The amendment revises the Technical Specifications by replacing the existing heatup and cooldown curves in Figures 3.1-1 and 3.1-2, respectively, with two sets of curves. The replacement curves are applicable for up to 12.5 and 15 effective full power years (EFPY), respectively.

H. B. ROBINSON STEAM ELECTRIC PLANT, UNIT NO. 2

Amendment No. 113  
License No. DPR-23

SAFETY EVALUATION BY THE OFFICE OF NUCLEAR REACTOR REGULATION  
RELATED TO AMENDMENT NO. 113 TO FACILITY OPERATING LICENSE NO. DPR-23  
CAROLINA POWER AND LIGHT COMPANY  
H. B. ROBINSON STEAM ELECTRIC PLANT, UNIT NO. 2  
DOCKET NO. 50-261

FIGURE  
3.1-1.a

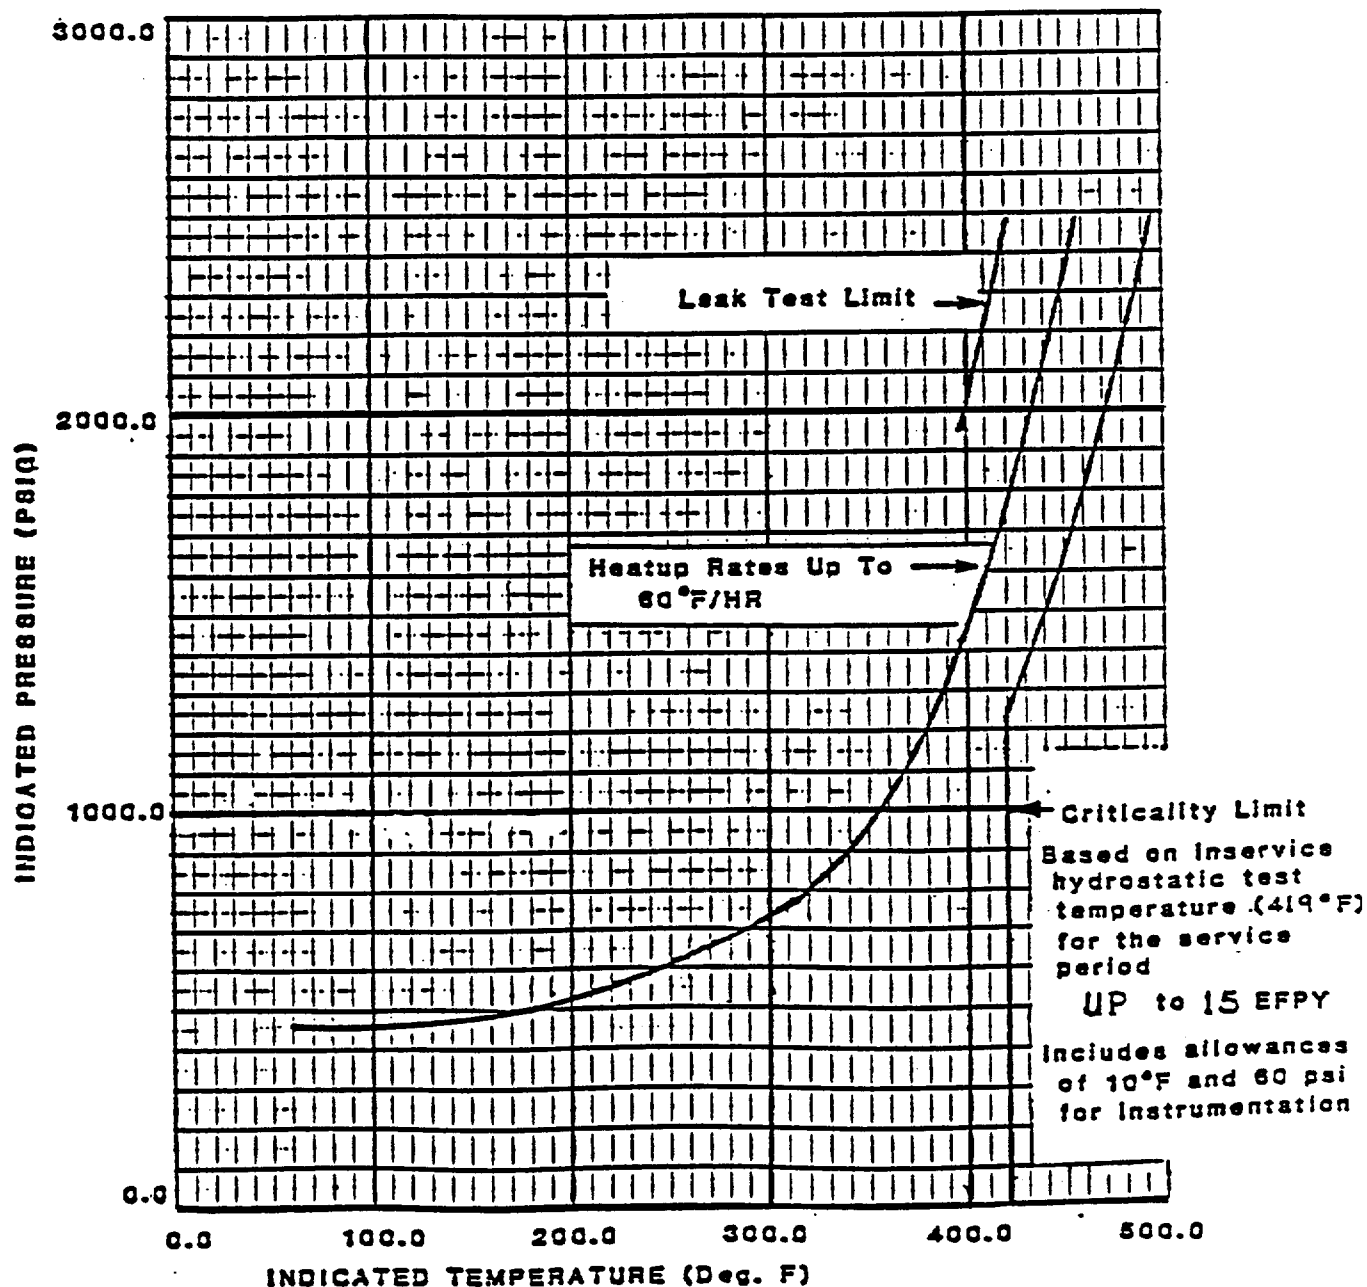
The staff used the unirradiated  $RT_{NDT}$  for beltline and closure flange materials, which were previously discussed, the neutron fluence estimates of the licensee, the Regulatory Guide 1.99 Rev. 1 method of estimating neutron irradiation damage, and Standard Review Plan 5.3.2 method of calculating pressure-temperature limits to evaluate the licensee's proposed pressure-temperature limits. Our evaluation indicates that the proposed pressure-temperature limits in Figures 3.1-1.a and 3.1-2.a meet the safety margins of Appendix G, 10 CFR 50, for a period of time corresponding to 12.5 EFPY. Also, it indicates that the proposed pressure-temperature limits in Figures 3.1-1.b and 3.1-2.b meet the same safety margins for a period of time corresponding to 15 EFPY.

Reactor Coolant System  
Heatup Limitations - Applicable  
Up To 12.5 EFPY
